### **2.1 DRAWING RPA-492-C-C33**

CONÇU C.ROY ING.	PROJET Réfection et modification de trois quais au lieu historique national du Fort-Lennox <i>Repair and Modification of Three Docks at Fort Lennox National Historic Site</i>					
					DESSINÉ JFB	TITRE <b>QUAI DU DÉBARCADÈRE</b> <b>DÉTAILS QUAI FLOTTANT ET RAMPE</b> <b>LANDING DOCK</b> <b>FLOATING DOCK DETAIL AND RAMP</b>					
01	ADDENDA #1	18/05/16	C.R.	C.R.	VÉRIFIÉ M.D.ROUSSEAU ING						
No	DESCRIPTION DE LA RÉVISION	DATE(A/M/J)	*	**	APPROUVÉ	No PROJET	SUBDIVISION	SUJET	SÉRIE	RÉV.	
REGISTRE DES RÉVISIONS * CONÇU ** APPROUVÉ						DATE 18/05/2016	RPA-492	0000	-   -	C33	01
 <b>SNC · LAVALIN</b> <small>SNC PROJET 631689</small>		CLIENT <b>AGENCE PARCS CANADA</b> <b>PARKS CANADA AGENCY</b>				ÉCHELLE 1:25

COUPE TYPE DE LA RAMPE  
**RAMP TYPICAL SECTION**

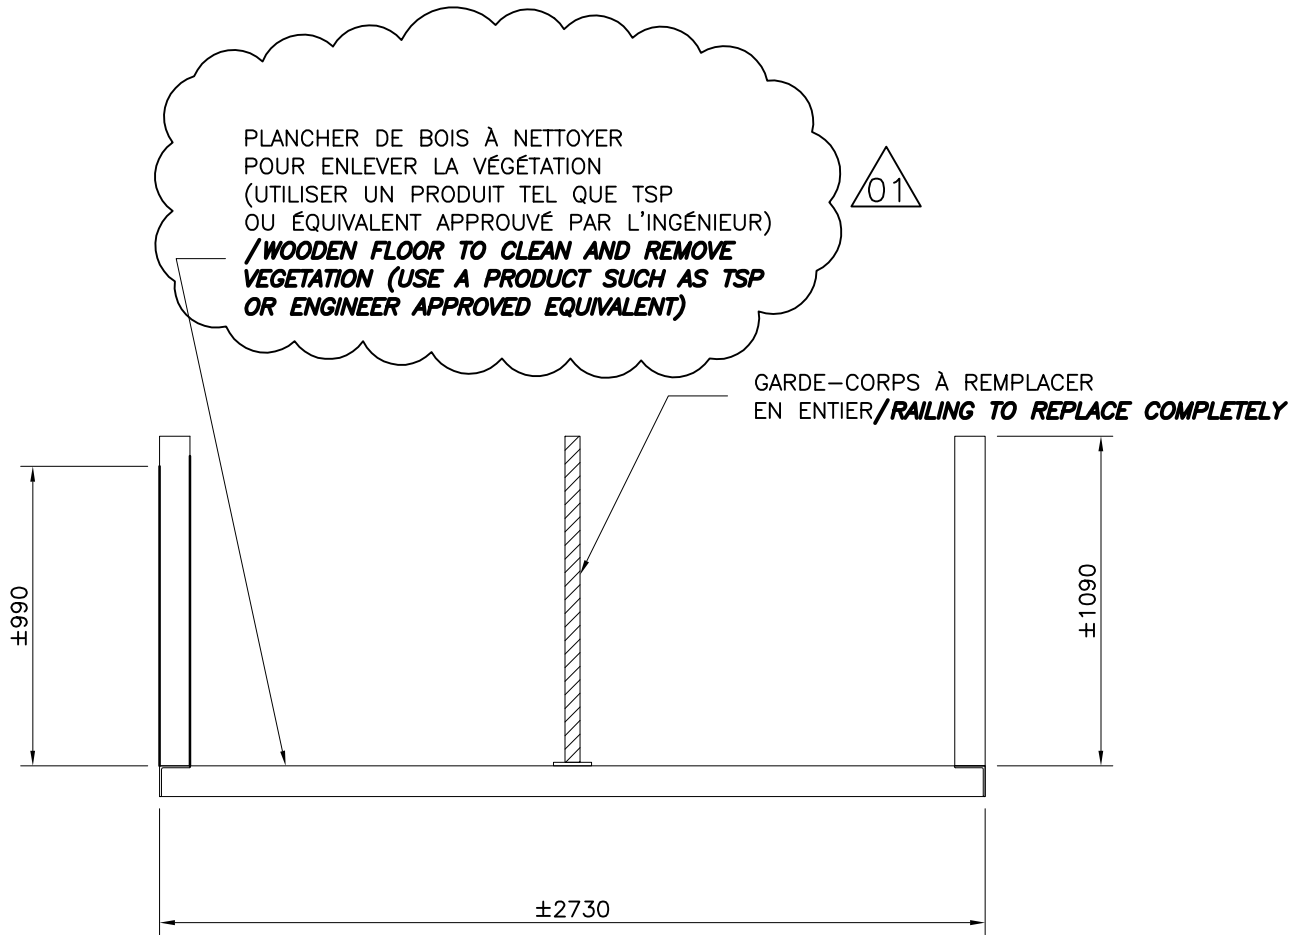
- .1 Note the modification on the Ramp Typical Section on drawing RPA-492-C33 enclosed.
